Car Stereo
Service Bulletin

Model: CDX-U8000

No. 335

Subject: Preventing Damage To Flex Cables.

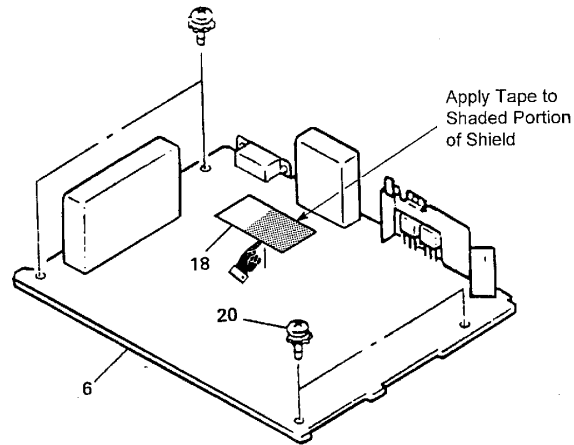
Symptom:
(51)

The shield plate mounted on the Main board may contact the flex cables between the Main board and the RF board, causing the cables to be damaged.

Solution: Add tape to the shield plate as shown below.
